THM 4L65E/4L70E 2009 CHANGES

10-17 Page 1 of 8

Figure 1

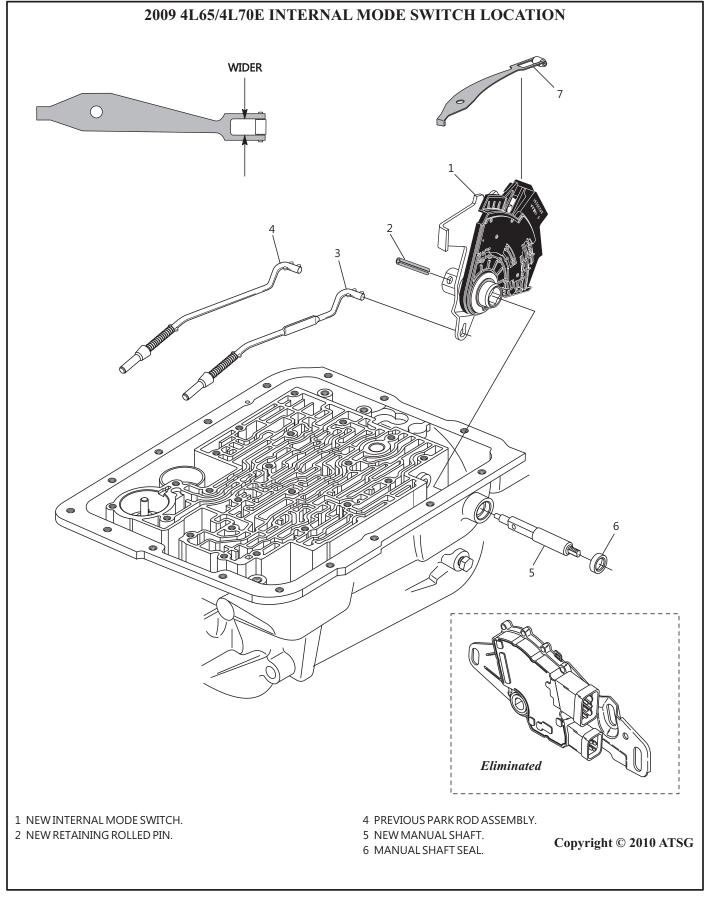
CHANGES: Beginning at the start of production for 2009 model year, General Motors replaced the external NSBU switch with an Internal Mode Switch (IMS), as shown in Figure 1. They also eliminated the 3-2 downshift solenoid and 3-2 downshift valve and spring from the valve body, as shown in Figure 6.

- (1) DETENT SPRING AND ROLLER Manufactured wider at the "fork" or roller end, to accommodate the Internal Mode Switch (IMS), as shown in Figure 1.
- (2) MANUAL SHAFT Now has flats on the internal part of the shaft, and a hole through it for the added rolled pin, to accommodate the added IMS, as shown in Figure 1.

- (3) PARKING ROD Now manufactured with a "Flat" in the middle of the park rod that produces the clearance needed in all detent positions for the added IMS, as shown in Figure 1.

Figure 2

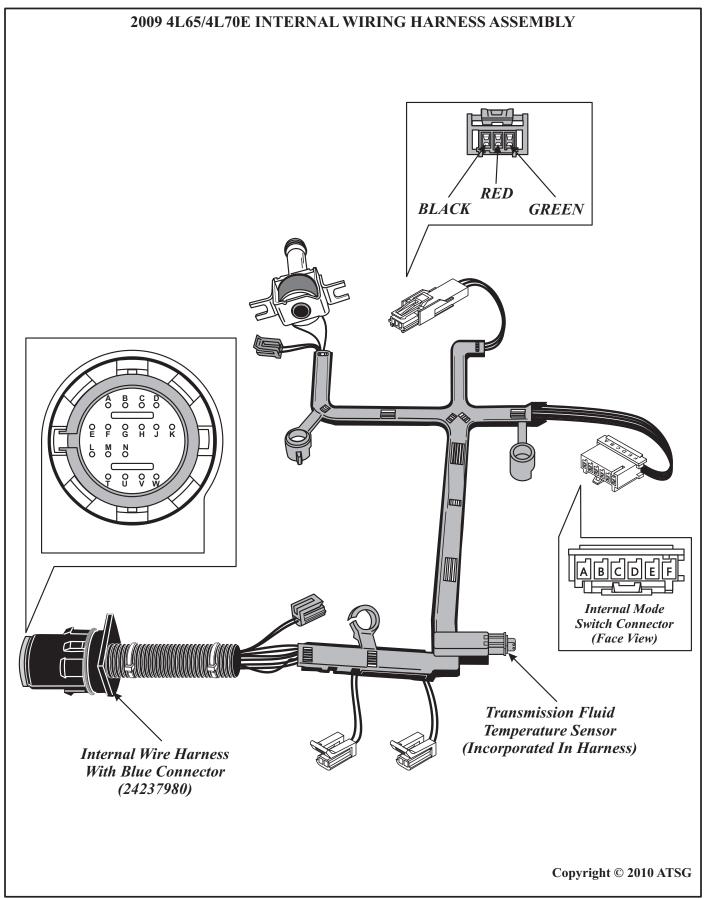
- (4) PRESSURE SWITCH ASSEMBLY Eliminated, as shown in Figure 6.
- (5) INTERNAL HARNESS AND CASE CONNECTOR With the elimination of the pressure switch assembly, the TFT Sensor was relocated in the new internal harness assembly, as shown in Figure 2. With the addition of the IMS, the pin functions must also change in the case connector. New case connector pin functions and pin identification is shown in Figure 3. New Internal Mode Switch connectors and pin functions are shown in Figure 4. We have also provided you with a wire schematic from the internal components to the external case connector in Figure 5.

Figure 6

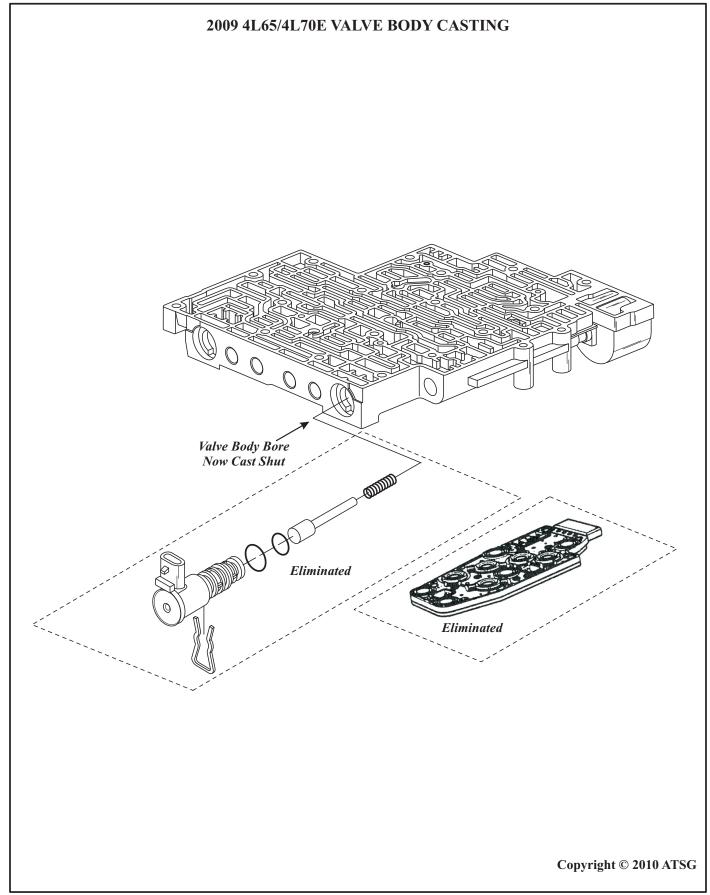
- (6) VALVE BODY CASTING Valve body is now cast shut where the 3-2 downshift solenoid was previously located and the pressure switch side of the valve body is no longer configured for the pressure switch, as shown in Figure 6.

Figure 7

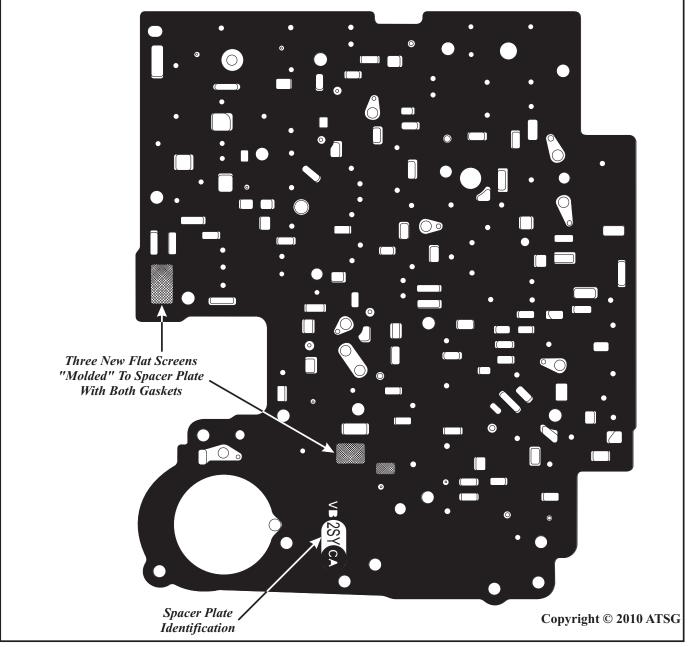
- (7) SPACER PLATE The valve body spacer plate also required elimination of the holes for the 3-2 downshift line-up and now has the gaskets molded to both sides of the plate. They also eliminated the two snap-in screens and installed three new flat screens molded in with the valve body gaskets, as shown in Figure 7.
